Coalbed Methane Stream Depletion Assessment Study – Raton Basin, Colorado

S.S. PAPADOPULOS & ASSOCIATES, INC.
Boulder, Colorado

March 2008

Reviewer's Comments and Response to Comments

Figure 3.1 Location of the Raton Basin in Colorado and New Mexico Showing Structural Features

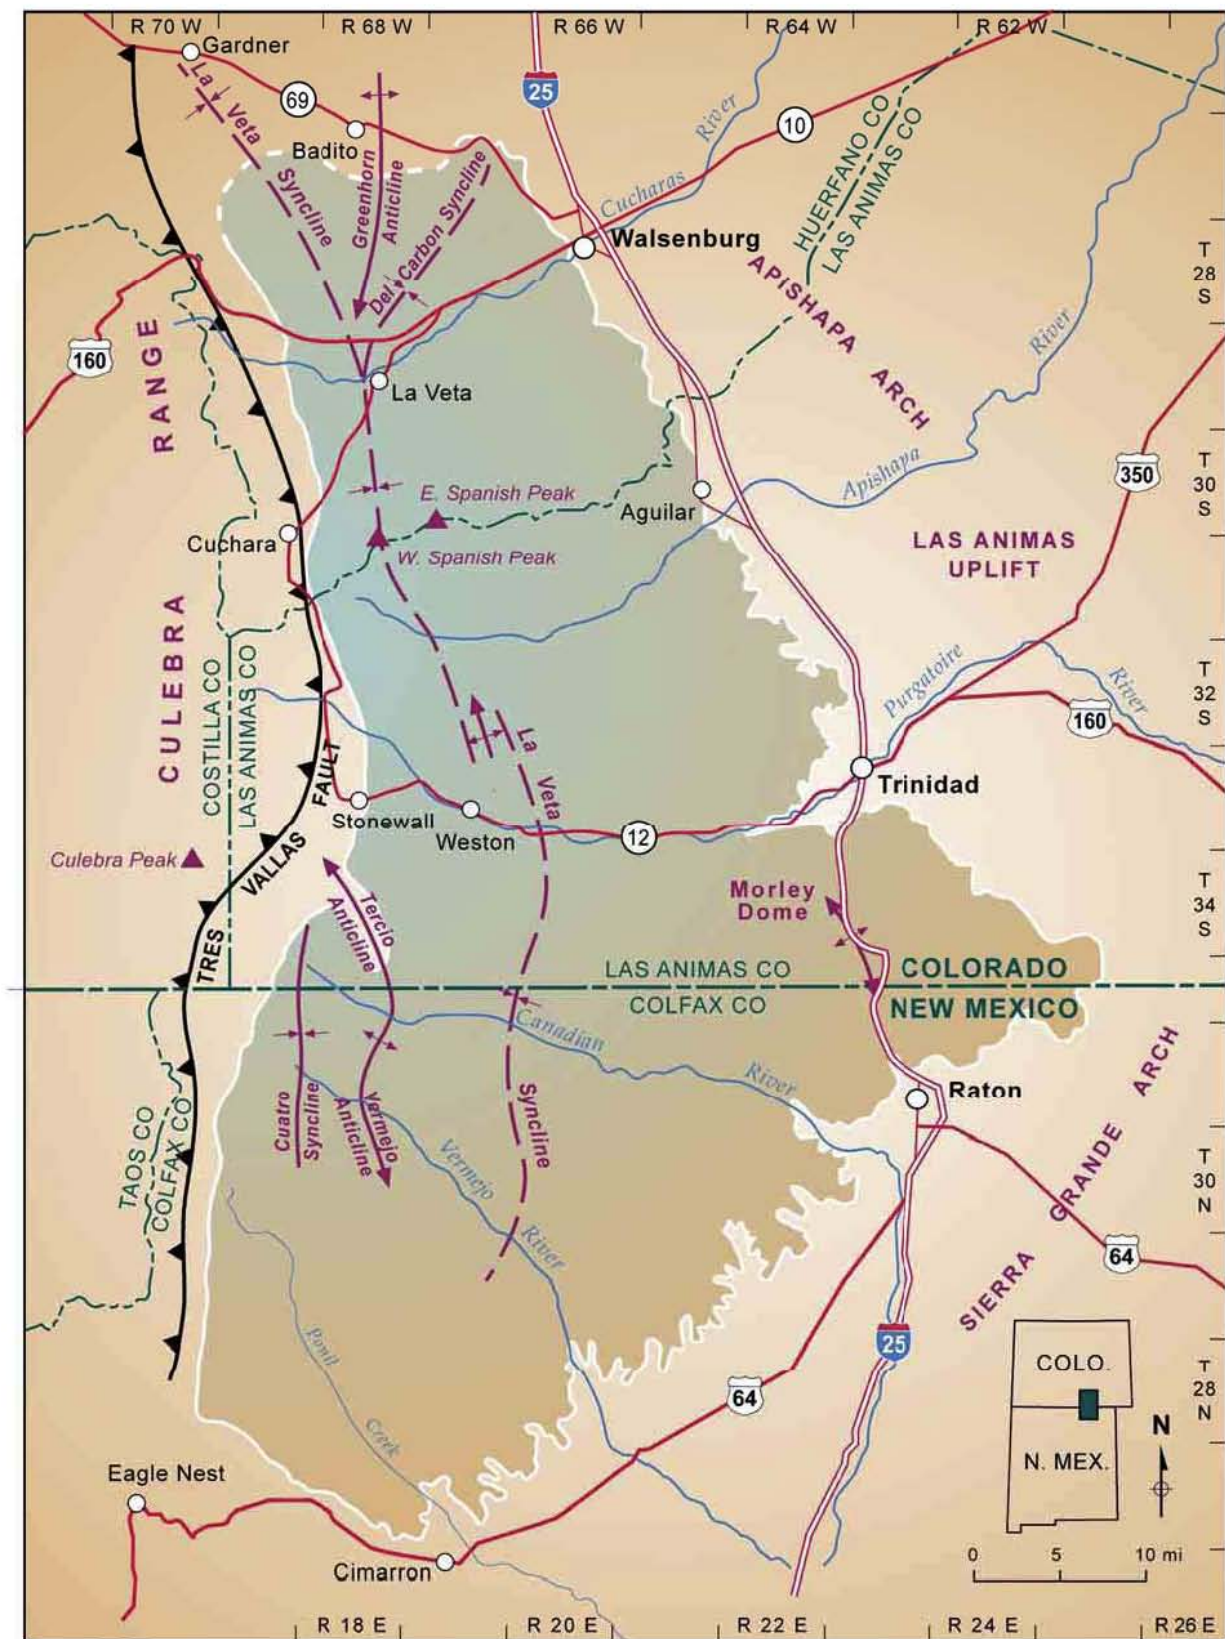
- 3) **Page 8, 2nd paragraph, 2nd sentence, and figure 3.1:** The “Wet Mountains” and “Sangre de Cristo Mountains” are not labeled in figure 3.1; “Las Animas arch” in text is labeled “Las Animas Uplift” in figure 3.1; and “Sierra Grande uplift” in text is labeled “Sierra Grande Arch” in figure 3.1.

- 29) Figure 3.1:** See editorial comment number 3.
- 30) Figures 3.3 and 3.4:** Indicate that lines of section are shown on figure 3.5.
- 31) Figures 4.2 and 4.3:** Add note to define the volume equivalent for a barrel (BBL) and a MCF. For example, 1 barrel (petroleum) = 42 gallons; 1 MCF = 1,000 cubic feet of gas at 60° Fahrenheit and an absolute pressure of 14.73 pounds per square inch. Check to see if these are the standard conditions used for measurement of gas in Colorado.

Figure 4.4 Cumulative Gas Production in the Raton Basin

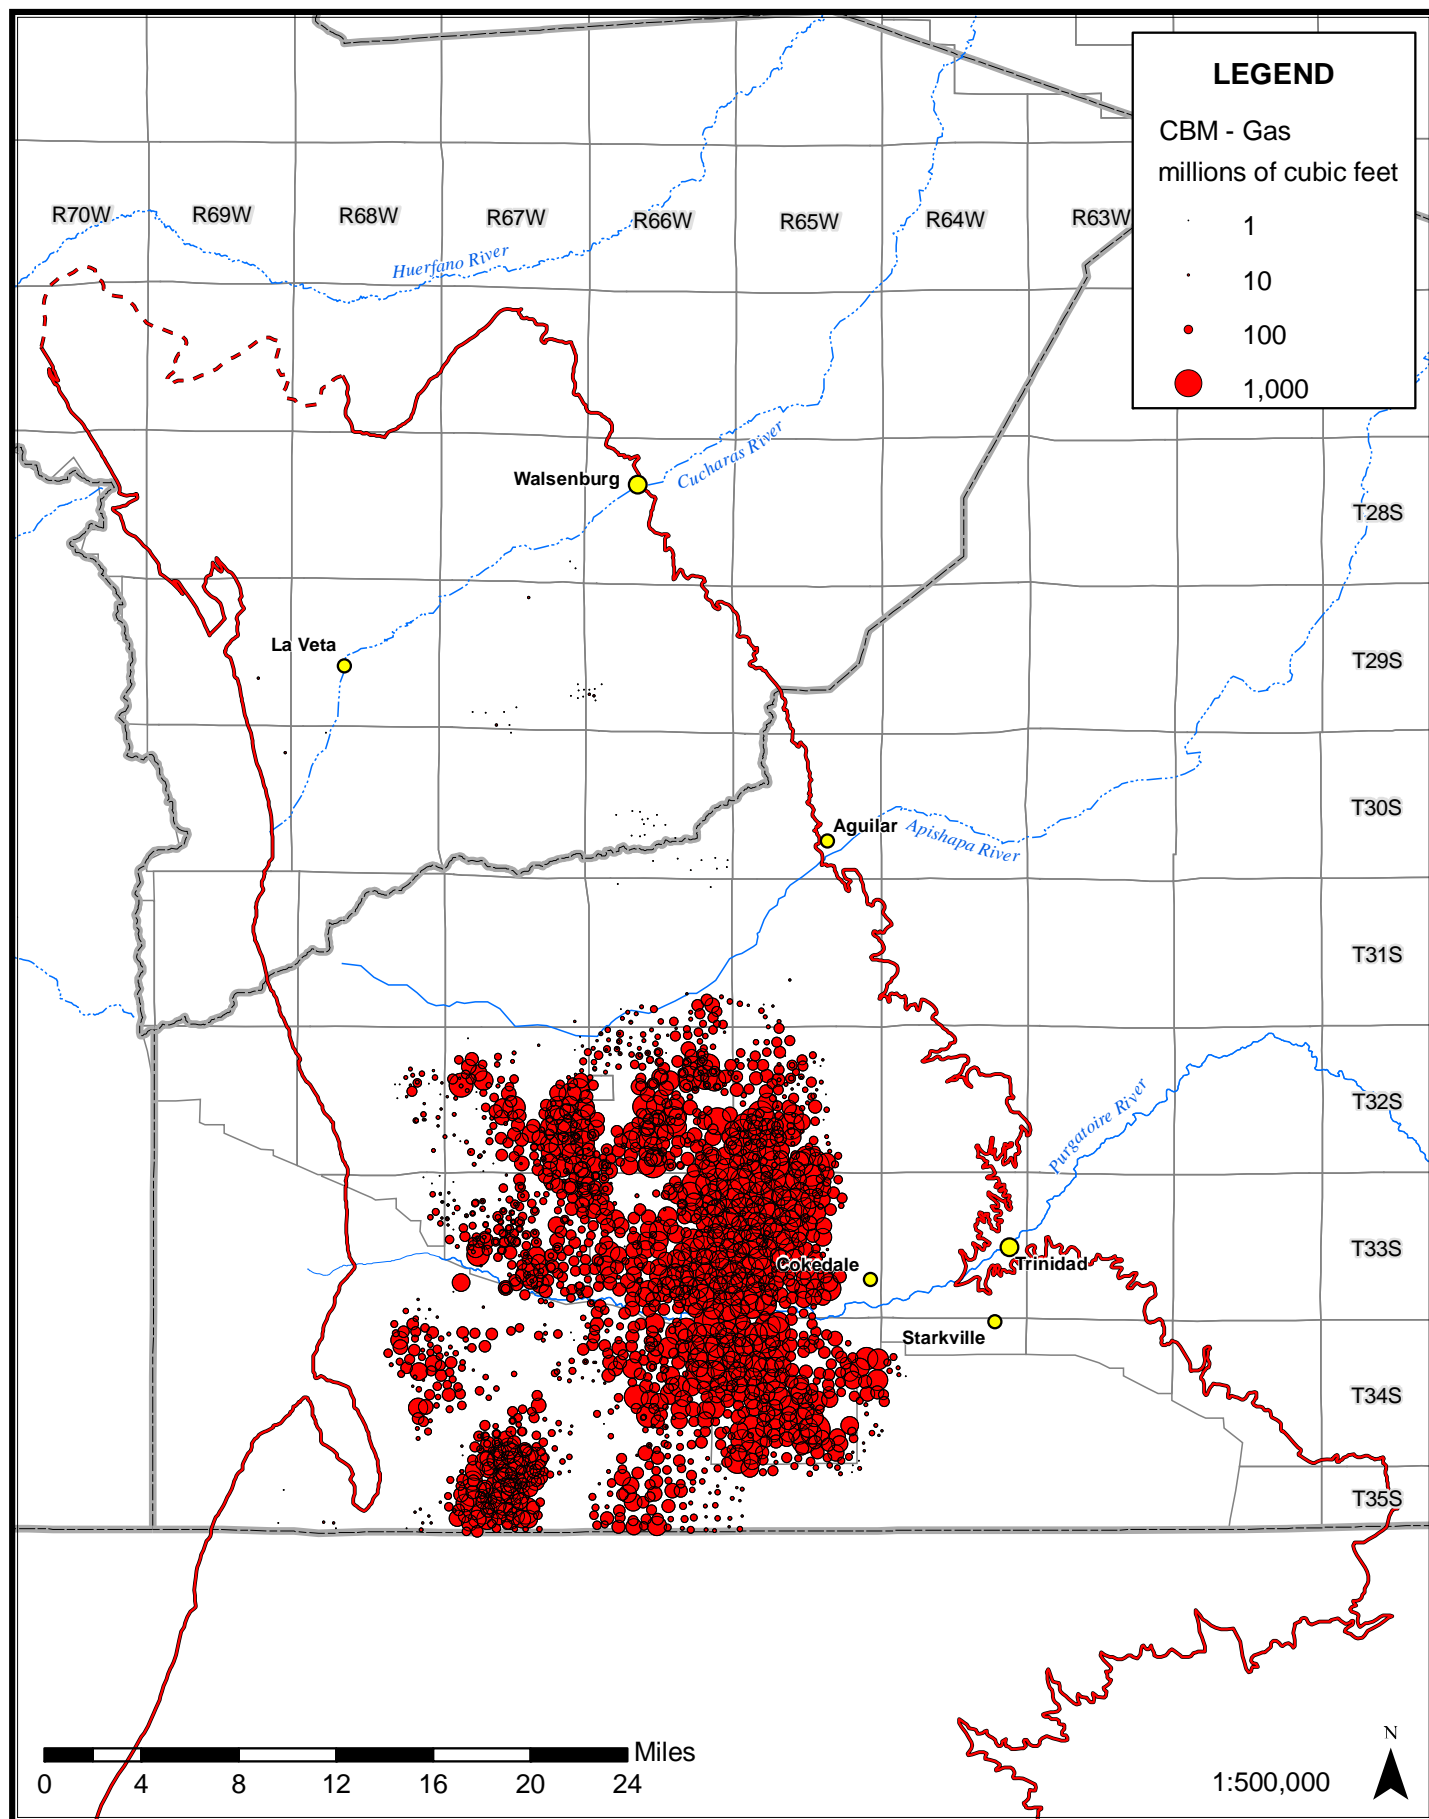
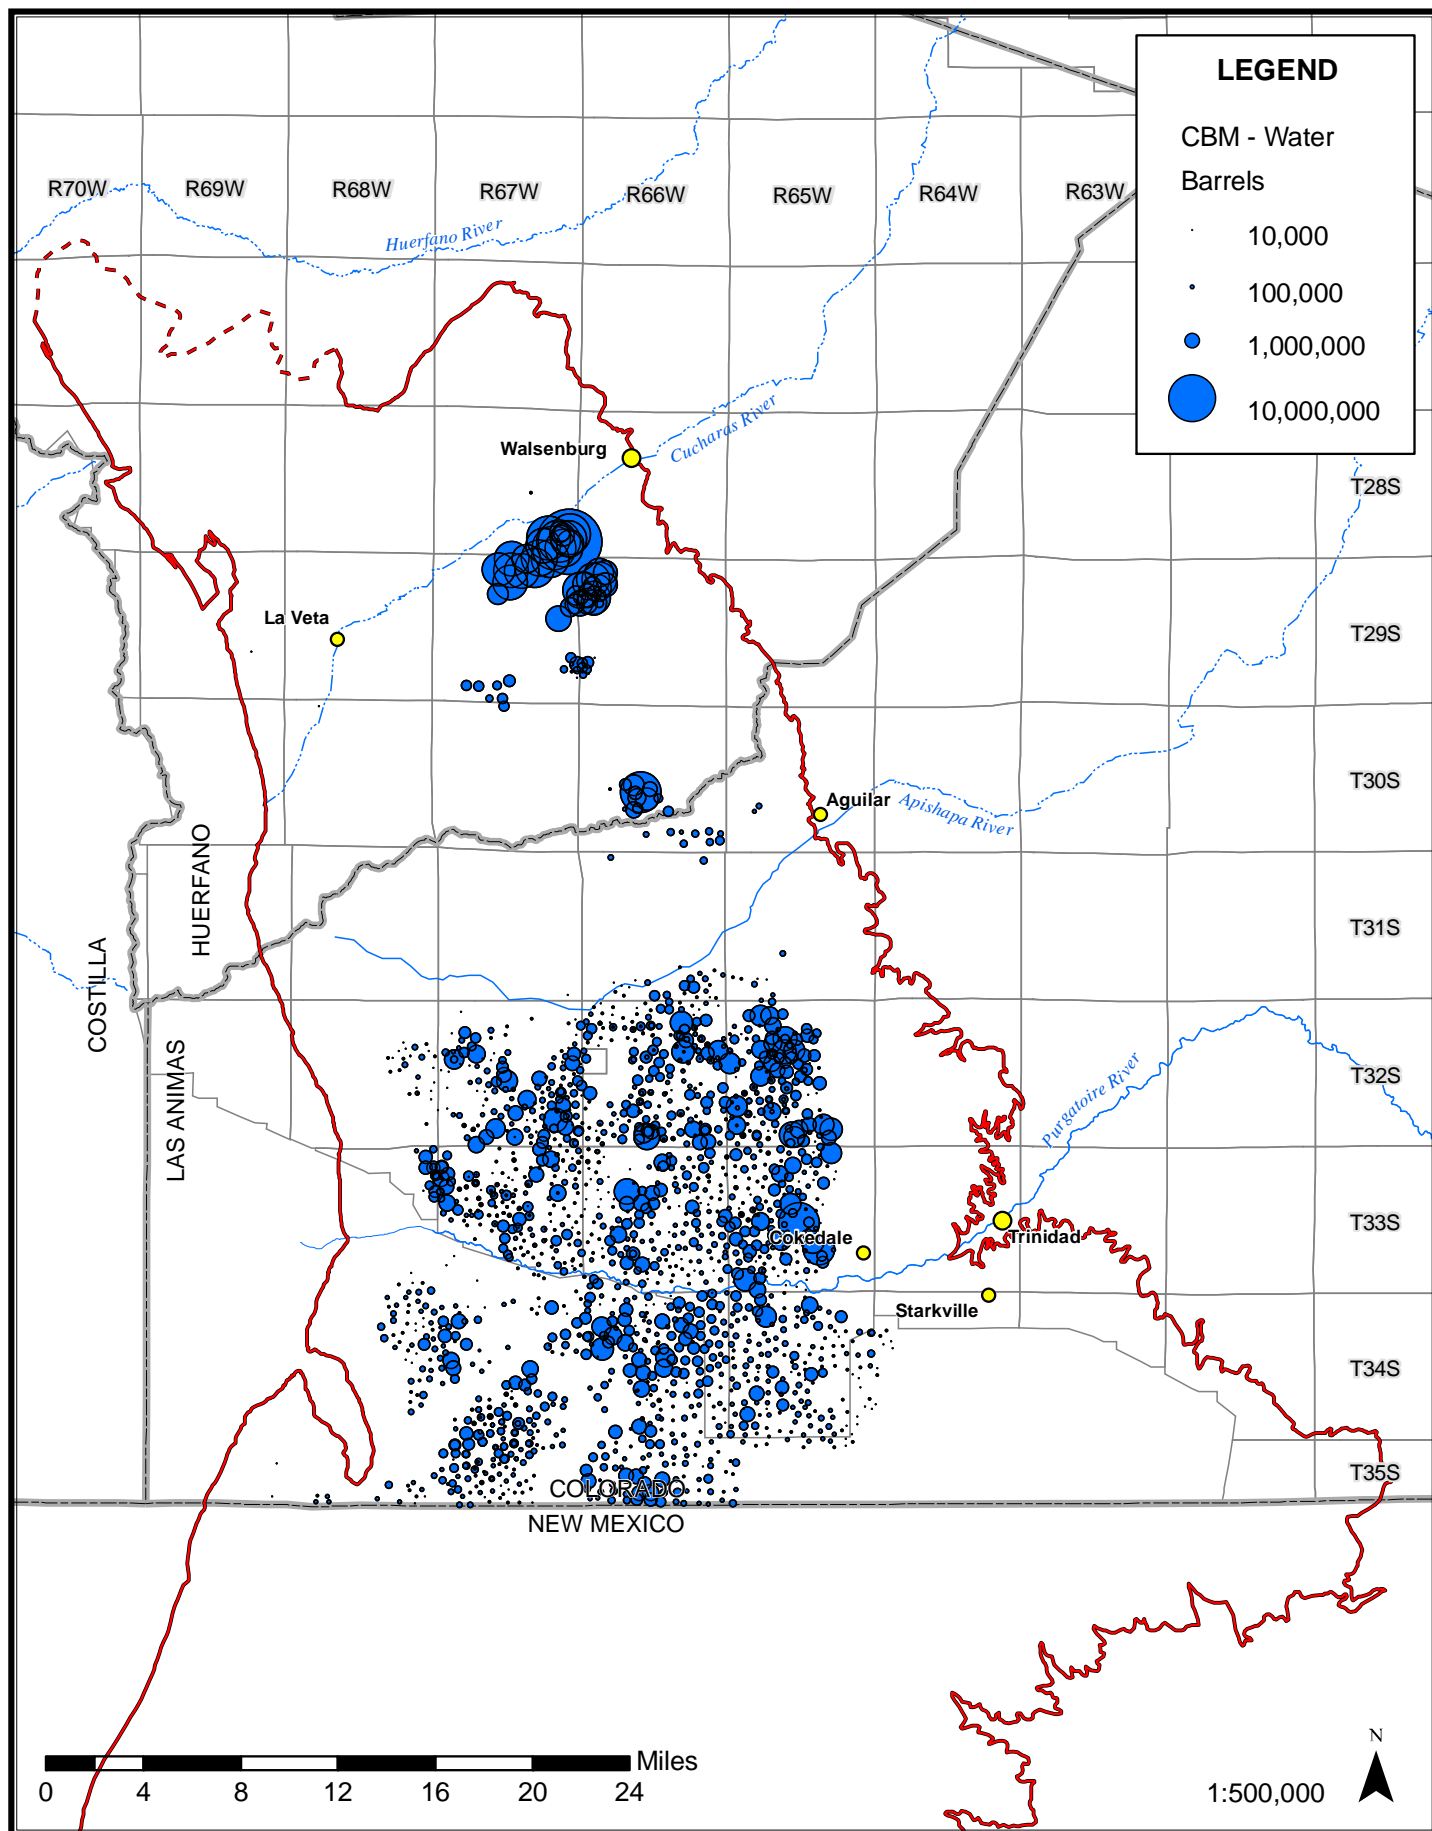
- 32) Figures 4.4 and 4.5:** Add date range or end date of accumulation. Add note about volume equivalents of BBLs.
- 33) Figure 5.1:** (after Watts, 2006[a](#))
